Bid Bulletin #01

PROJECT: Ashland Community Resource Center
Ashland, NE

663-003-10

ADDENDUM NO. 1

SITE PLANTING PLAN

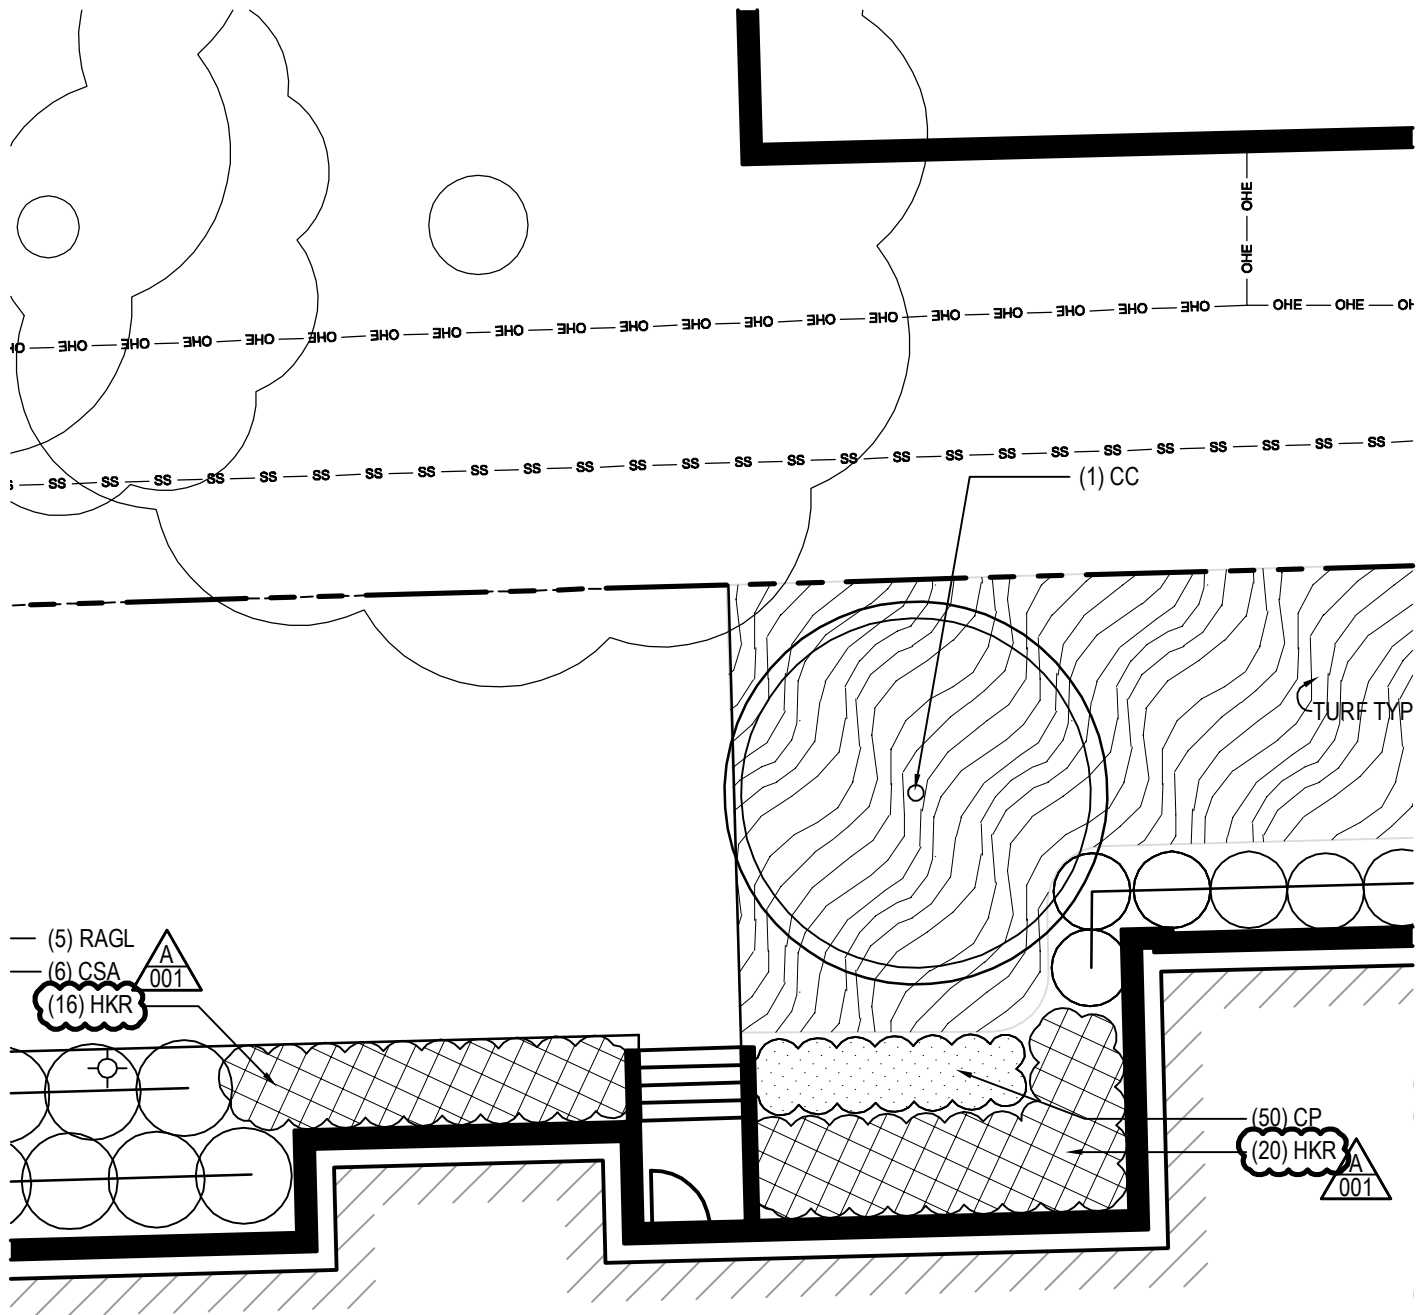
Item 1-6: Refer to Sheet L4.01 – Site Planting Plan

The quantity of “HKR” plants has been revised. See SDL-001 for additional details.

Heat Pump Supply Revision
 Supplemental Drawing: SDM-001
 Revision of Sheet: M3.01
 Date: 01/31/13

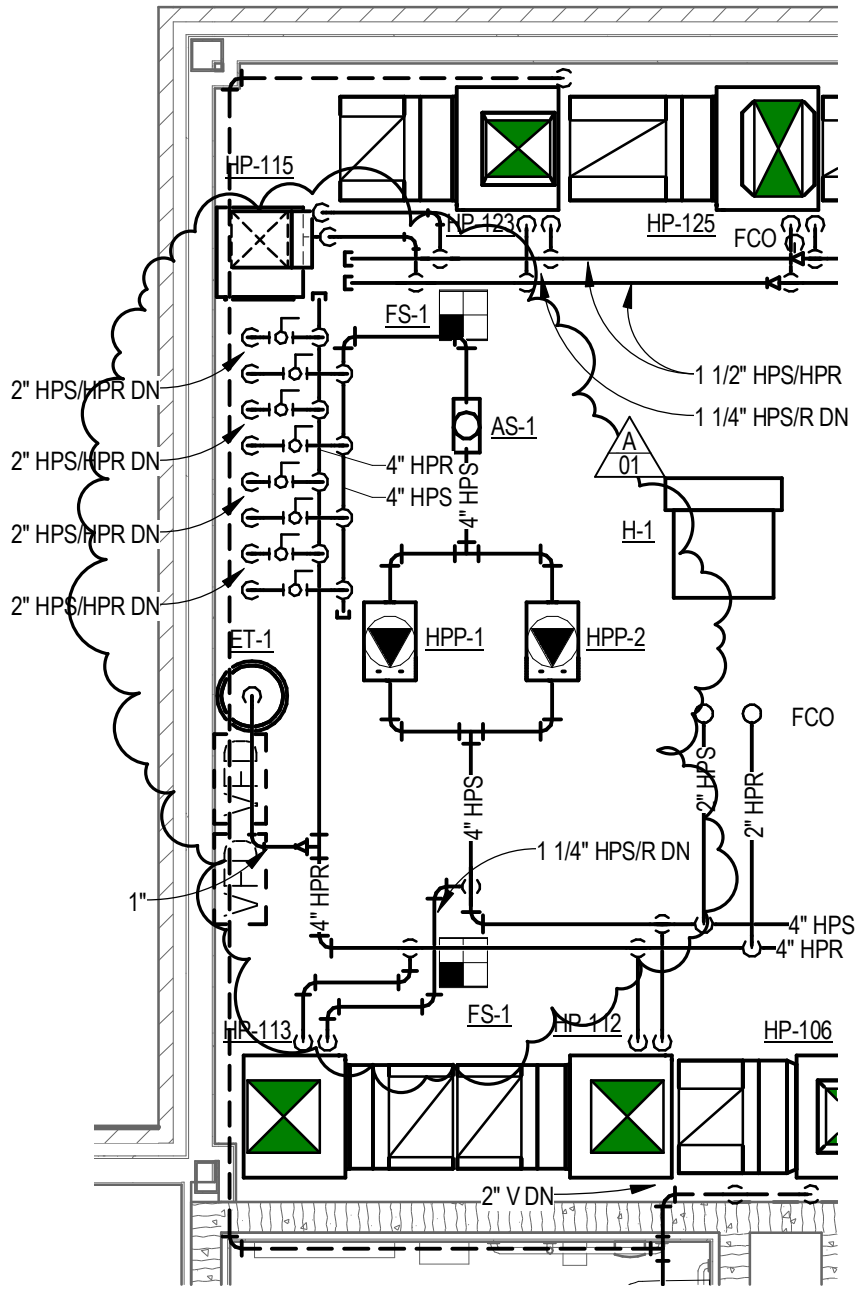
Item 1-44: Sheet M3.01 – Enlarged Mechanical Plans

The heat pump supply piping has been revised along with the location of the air separator (AS-1); see SDM-001 for additional details.

REVISED HEAP PUMP PIPING SCHEMATIC

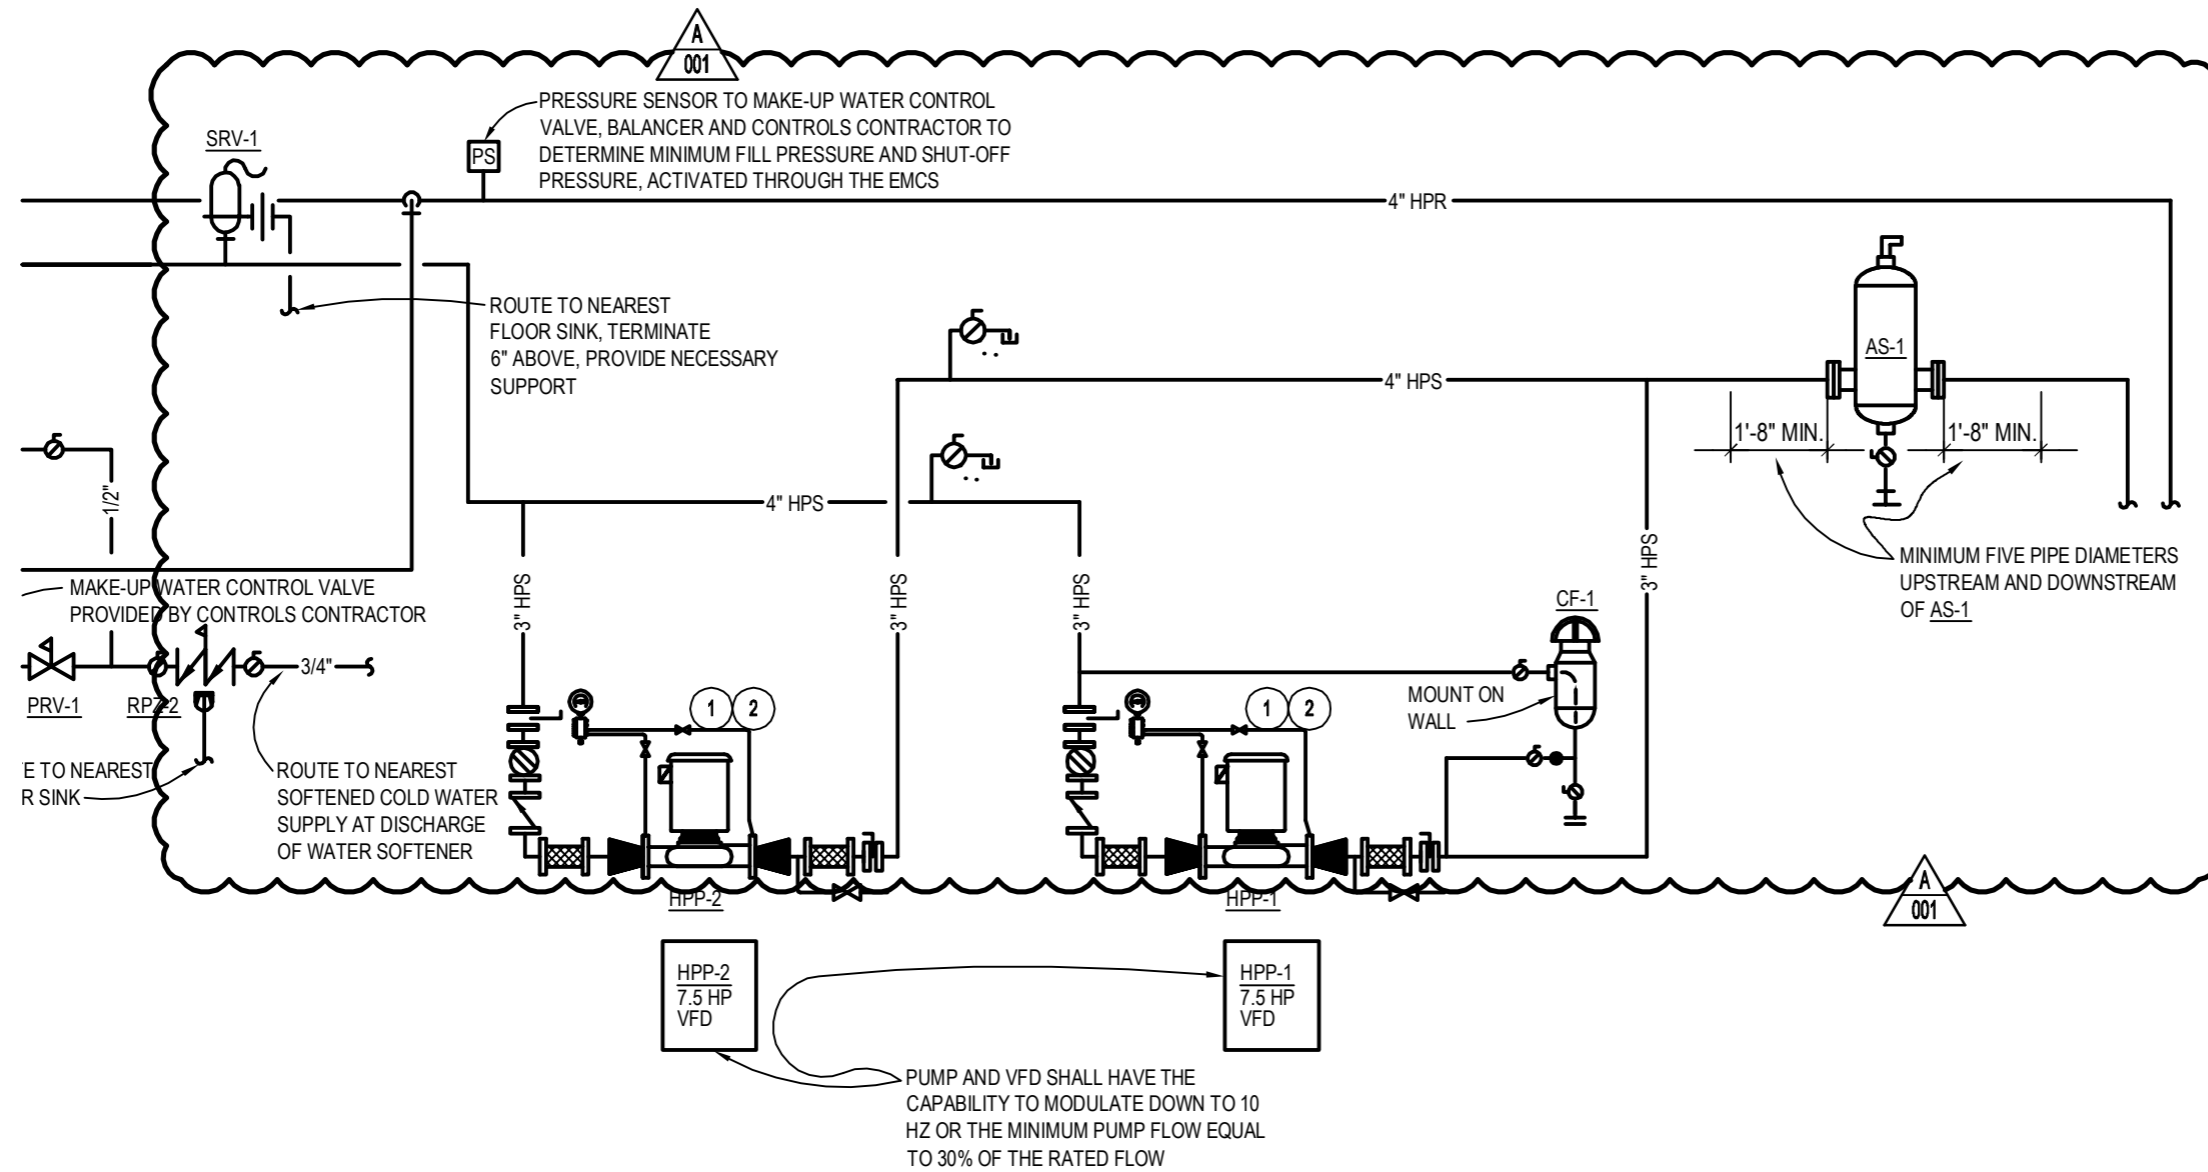
Item 1-45: Sheet M4.03 – Heat Pump Piping Schematic

The air separator (AS-1) and safety relief valve (SRV-1) have been relocated; see SDM-002 for additional details.
